**Halton District School Board****Addendum No. 2****RFT 26-030 Oakville #5 Elementary School & Child Care Facility**

## RFT 26-030 Oakville #5 Elementary School &amp; Child Care Facility

**ADDENDUM NO. 2****Issued January 29, 2026**

**Structural Addendum No. 1  
Project Addendum No. 2**

Name: **OAKVILLE #5**  
**PUBLIC ELEMENTARY SCHOOL**  
OAKVILLE, ONTARIO  
Description: **2018-2019 GRAADING PLAN**

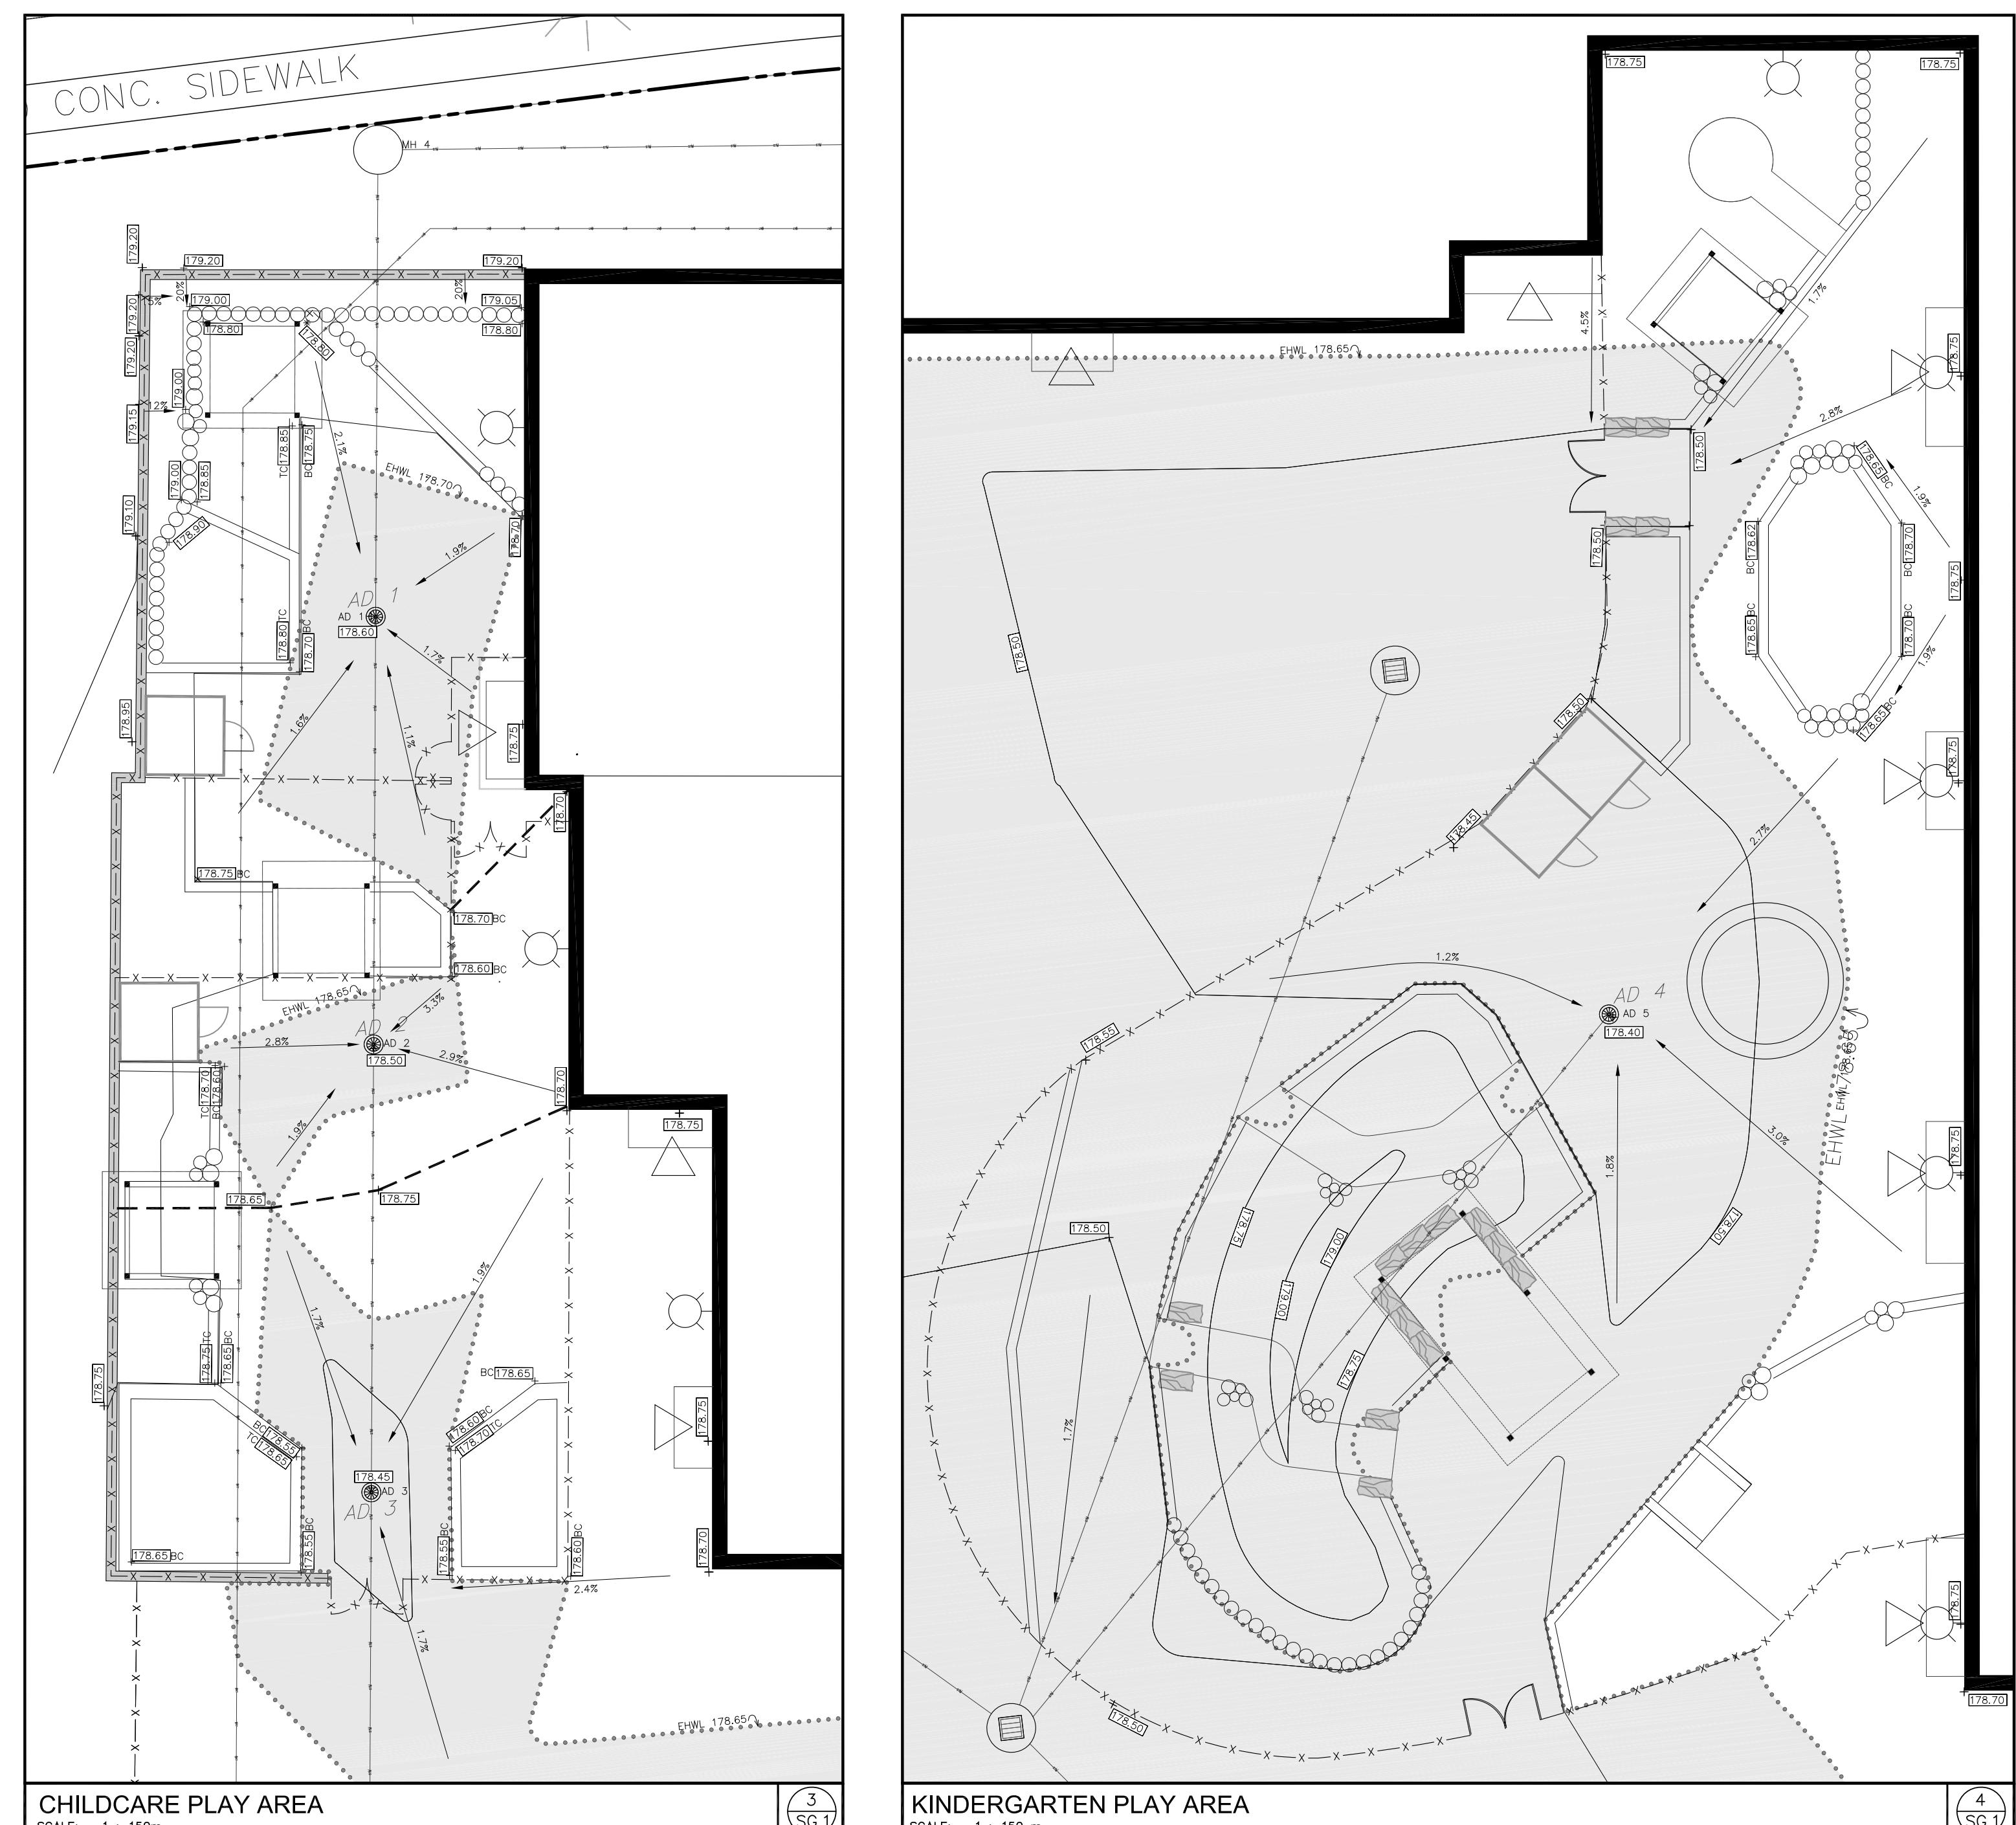
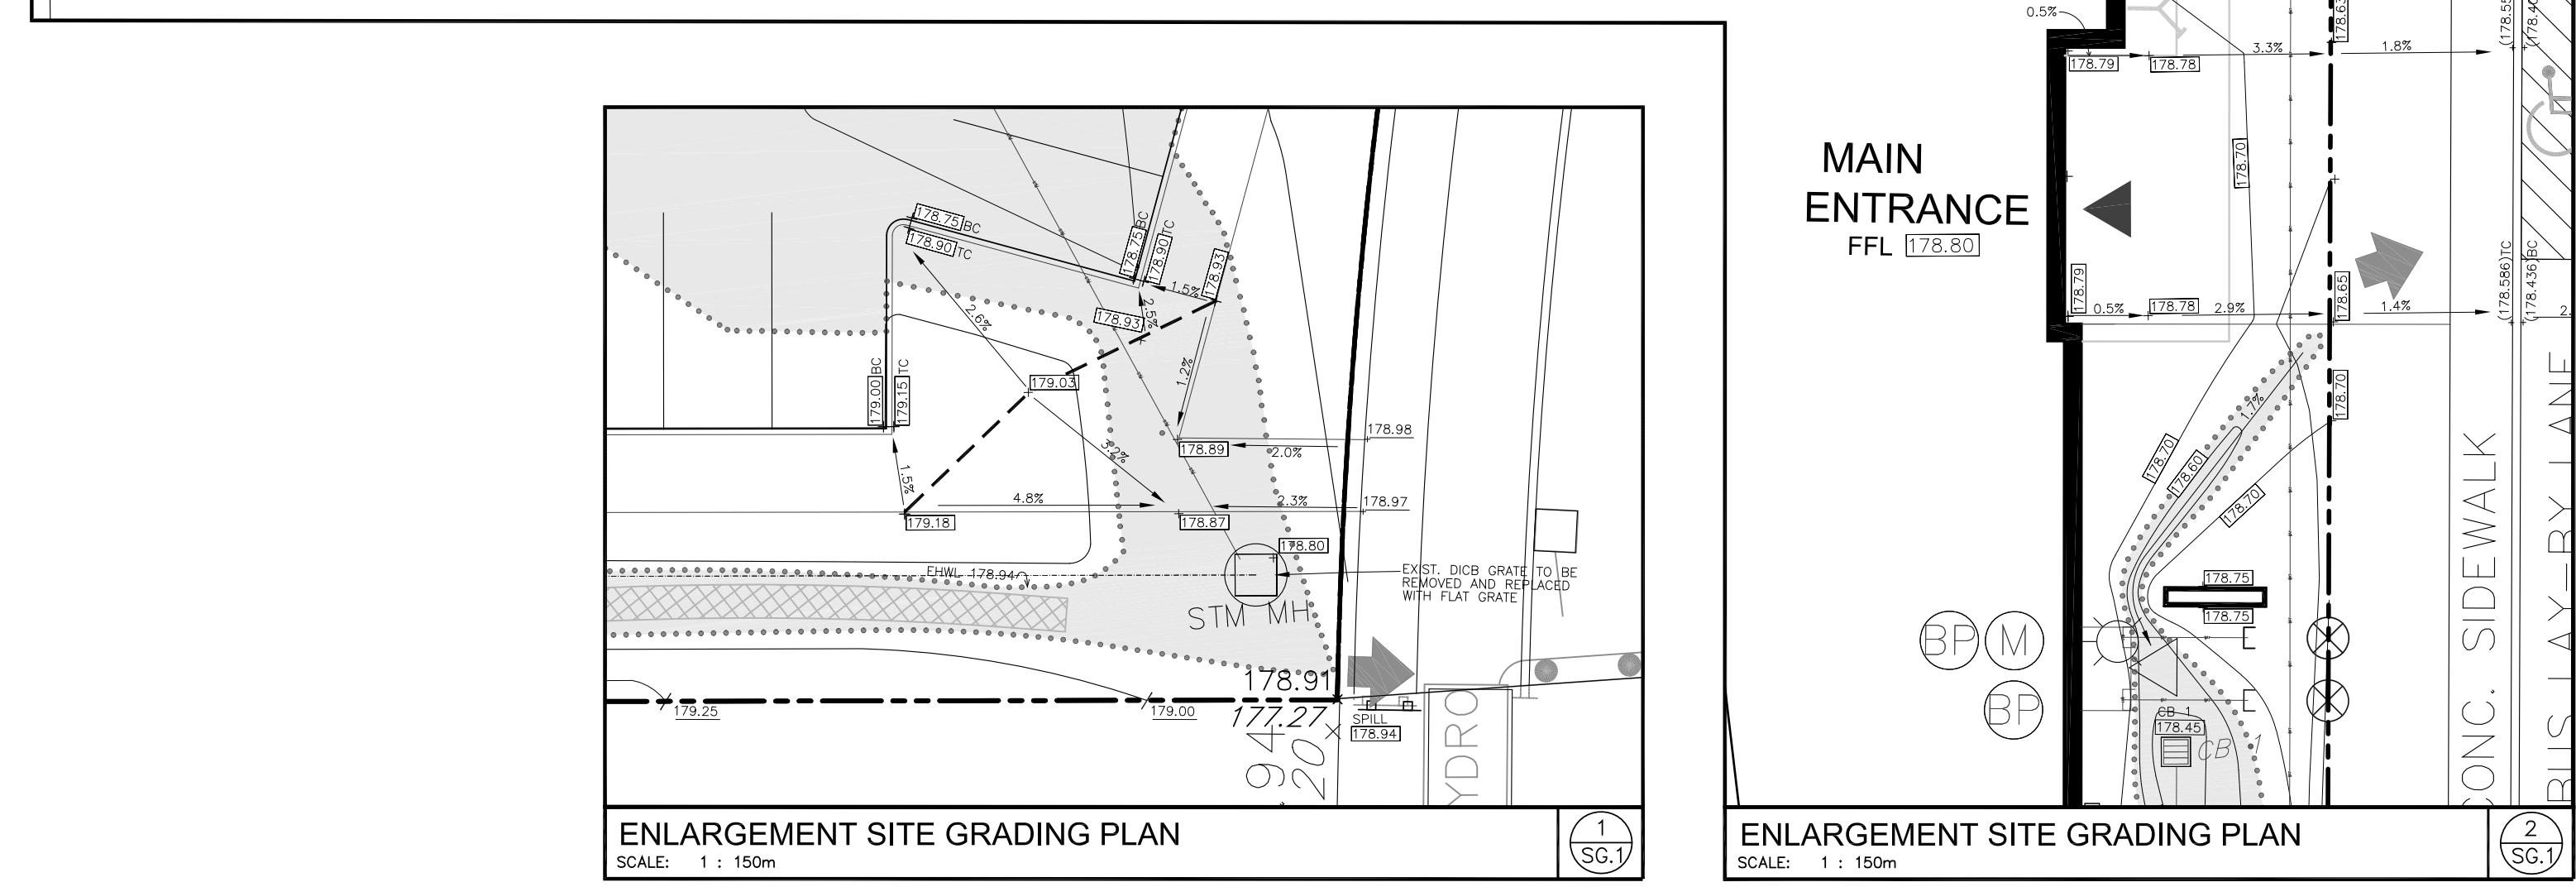
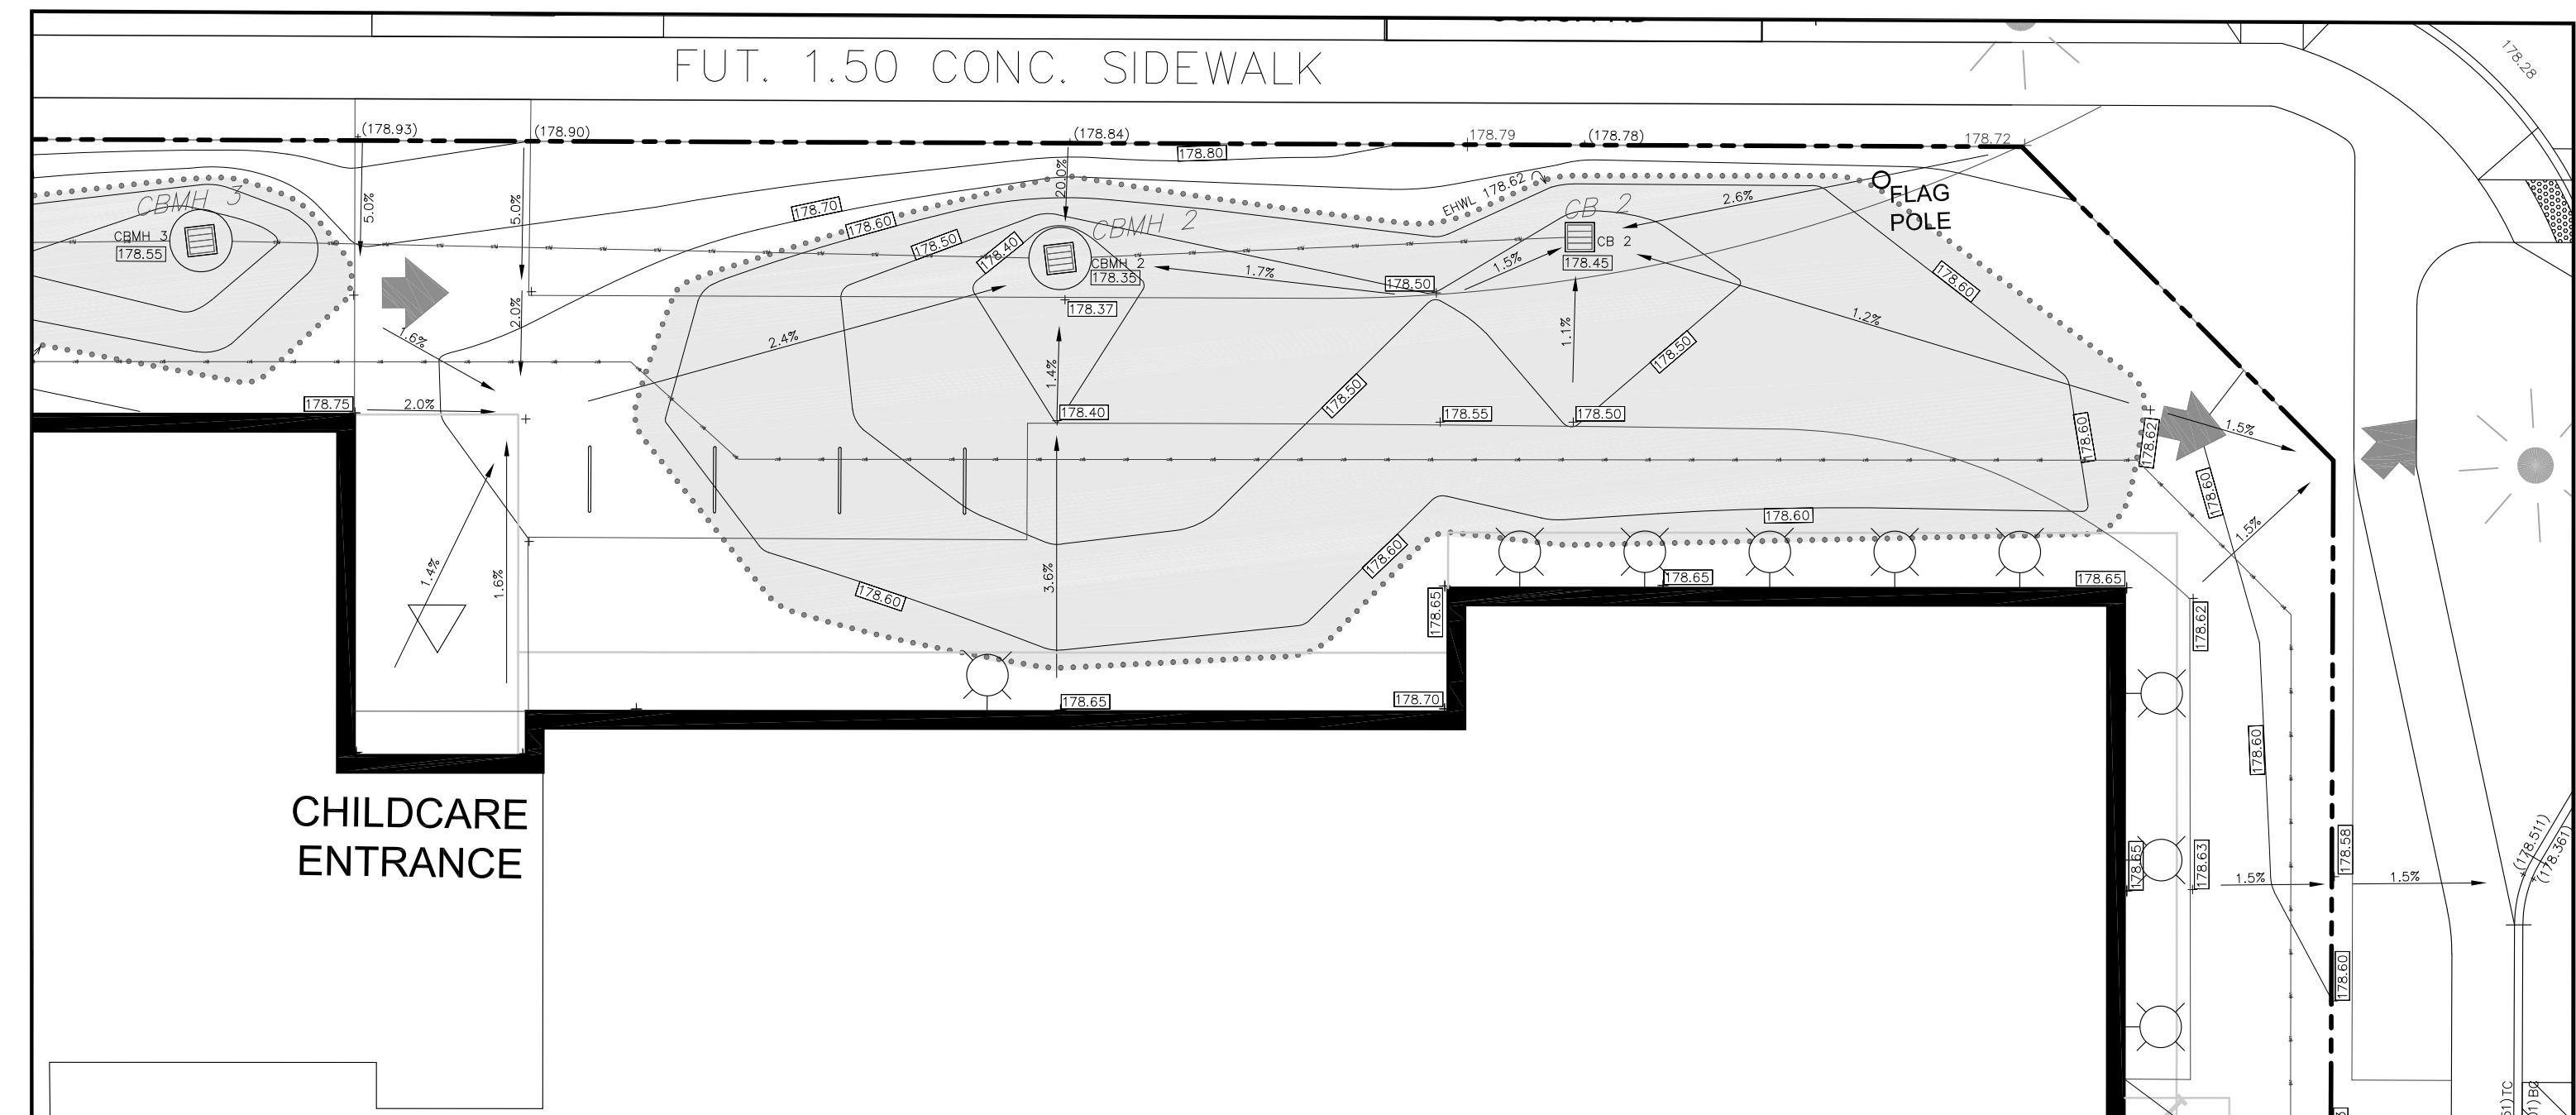
QUESTION 6: Drawing SG.1 – Site grading plan – please provide an overlay of the existing grades from file No. 10487-T.

.1 REPLACE full size 36" x 48" drawing, 'SG.1' with enclosed 'SG.1 SITE GRADING PLAN', dated January 28, 2026.

ANSWER 6: The site grading plan, SG.1, has been updated to include existing grades. Refer to attached updated SG.1.

DATE FEB. 2019	19001
DRAWN S.NUVE	DRAWING
CHECKED G.F.	S3.2

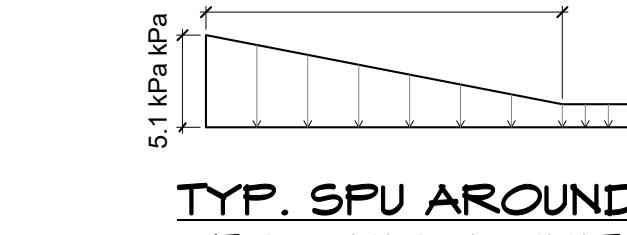
- A. Drawing S0.0:
  - a. Revised Foundation Note 1.
- B. Drawing S3.2:
  - a. Revised lintel sizes along grid line 3 to accommodate sun shades.

## GROUND FLOOR PLAN - VENTILATION

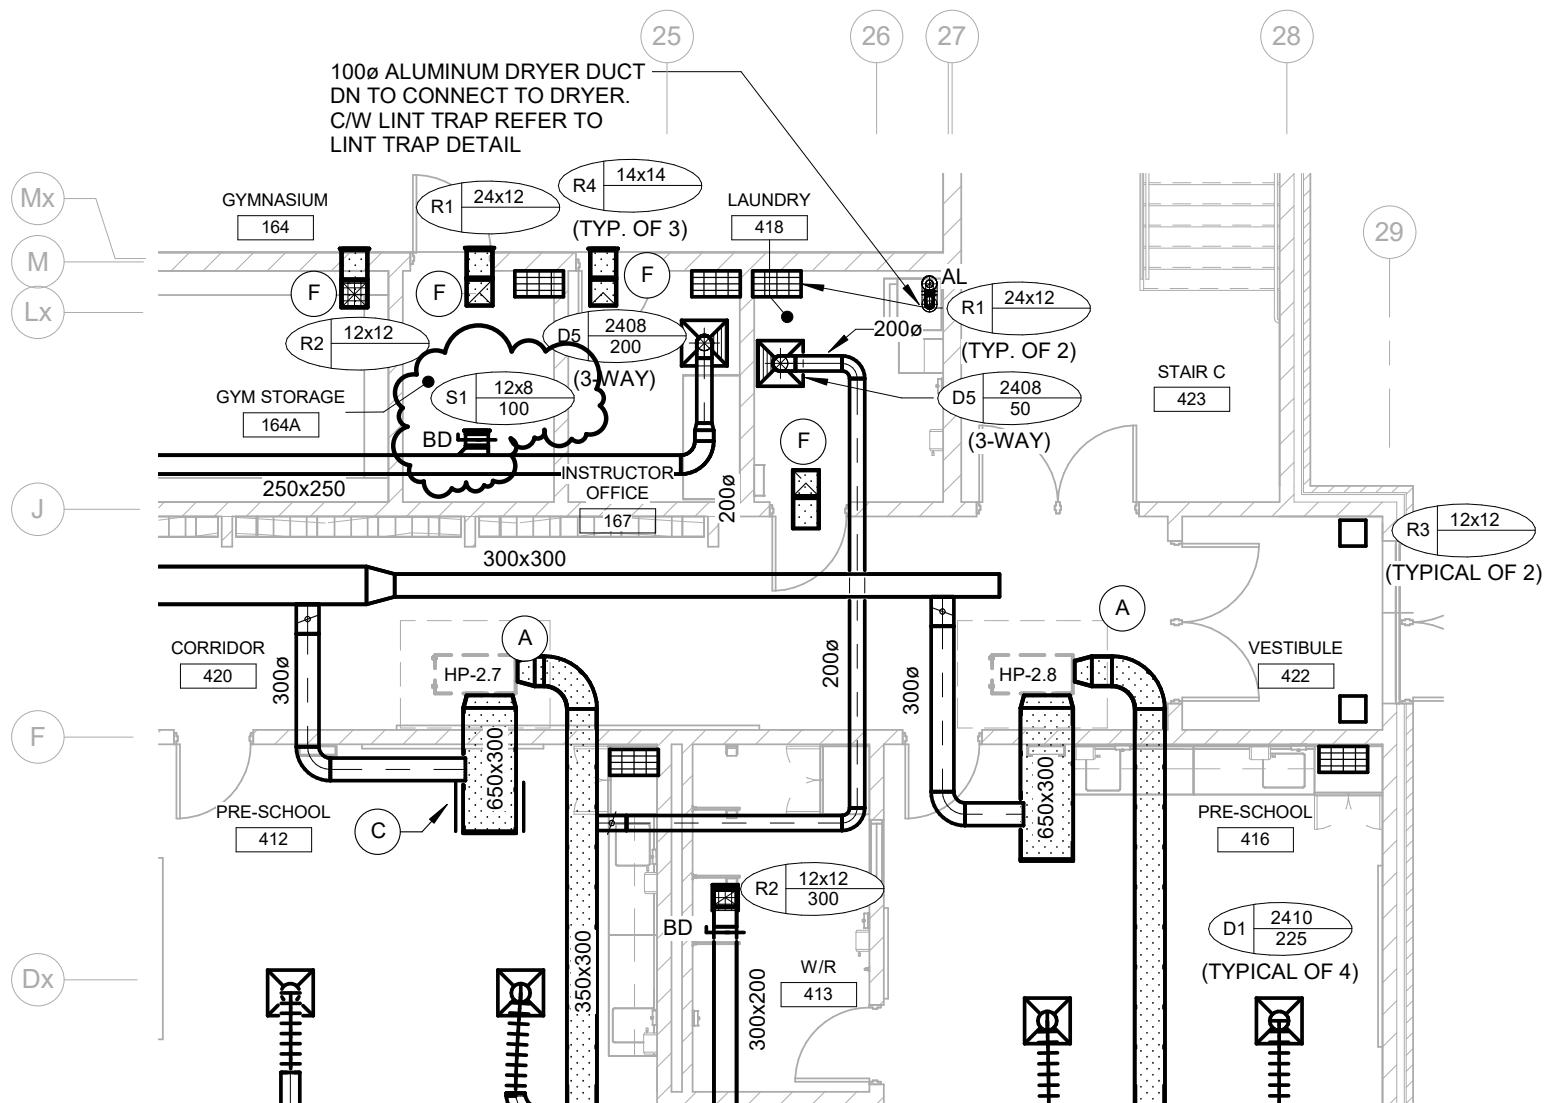
1.0 Reference Drawing M401 and Attached Sketch AD01-M01  
.1 In Gym Storage 164A, revise ductwork as indicated on attached sketch AD01-M01.
